Work Order ID 132170

Item Name: Aft Crosstube - High 407

Reference: REWORK PER ECN 15-557

DRAWN	RF		
CHECKED	4P		
MFG. APPR.	4P		
APPROVED	4P		
DE APPR.	4P		
DATE	15.03.20		
DART AEROSPACE LTD HAWKESBURY, ONTARIO, CANADA DRAWING NO. D407-667-245 TITLE CROSSTUBE ASS'Y (407 HIGH AFT) REV. G SHEET 1 OF 4 SCALE NTS COPYRIGHT © 2002 BY DART AEROSPACE LTD THIS DOCUMENT IS PRIVATE AND CONFIDENTIAL AND IS SUPPLIED ON THE EXPRESS CONDITION THAT IT IS NOT TO BE USED FOR ANY PURPOSE OR COPIED OR DISSEMINATED TO ANY OTHER PERSON WITHOUT WRITTEN PERMISSION FROM DART AEROSPACE LTD.

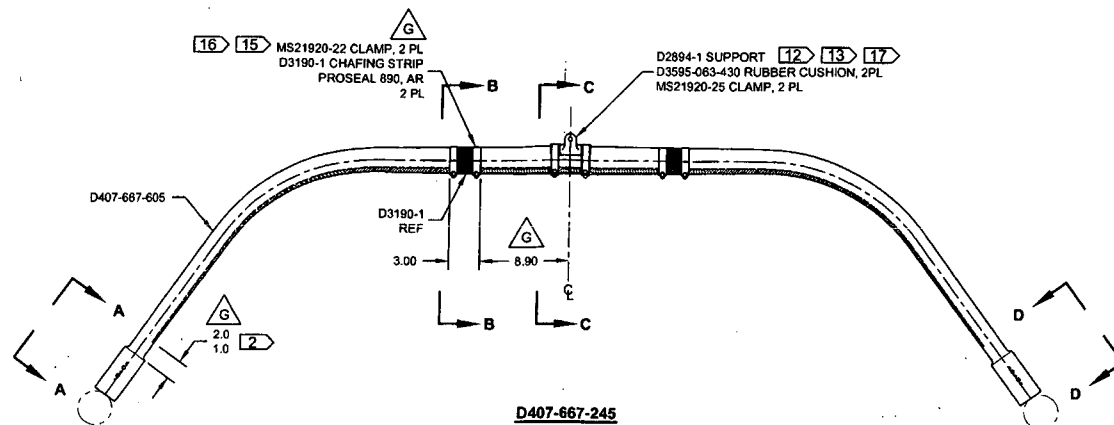
G	INCORP. DEO's D407-667-245-F1/F2 (ZN D8-1, A8-1, D5-2, B6-2, C6-2); 8.90 WAS 8.53 (ZN D5-2); TORQUE REDUCED FOR CHAFING SHIELD (ZN A8-1); FINISH REVISED TO ALLOW MANUFAC. FLEXIBILITY (ZN C8-1)	RF	15.03.20
F	REFORMAT NOTES TO NEW STANDARDS (ZN B8-1); RELOCATED FLAG # 6 (ZN A8-3) PER NCR 210; REMOVED REF. & ADD TOLERANCES (ZN C6-3, C4-3 & D2-3)	RF	08.11.06
E	8.02 AND 8.53 WERE 8.40 AND 8.90 (ZN D5-2); REORGANIZED VIEWS AND REFORMATED DRAWING TO CURRENT STANDARDS. REASONS: CLAMPS MOVED 0.375 TOWARD CL TO ELIMINATE INTERFERENCE WITH AIRCRAFT MOUNTS. REFERENCE: PAR#08-21 AND ECU#1225	MB	08.07.24
D	ADD VIEW FOR OEM SKID HOLES, ROTATE ORIENTATION OF CLAMPS SECTION F-F, REMOVE .851 ABRASION STRIP, ADD MAGNOBOND 6398, ADD CUSHION	PH	07.02.07
C	ADD HOLES AND NUT PLATES FOR COMPATIBILITY WITH BHT/AA SKIDTUBES	PH	05.07.26
B	ADD CHAFING SHIELD	CP	03.05.21
A	NEW ISSUE	CP	02.05.13
REV.	DESCRIPTION	BY	DATE
DESIGN	4P

D407-667-245
ASSEMBLY DETAIL
(VIEW LOOKING FWD)

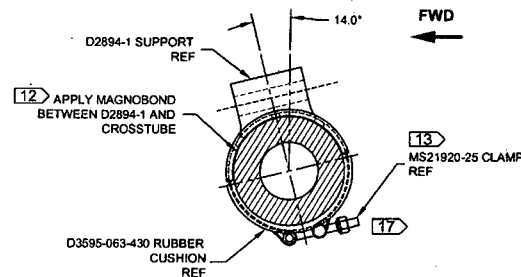
NEEDS TO BE REWORKED PER ECN 15-557

REMOVE CHAFFING SHIELDS AND CLAMPS (MS21920-22)
AND SCRAP

REPLACE WITH NEW PER NEW DRAWING REV G

1- Install chaffing shield as per D407-667-245 using DT10096 to establish 8.90
dimension. Top holes should be facing up.

****Ensure chaffing is to be position "overlap" AFT****
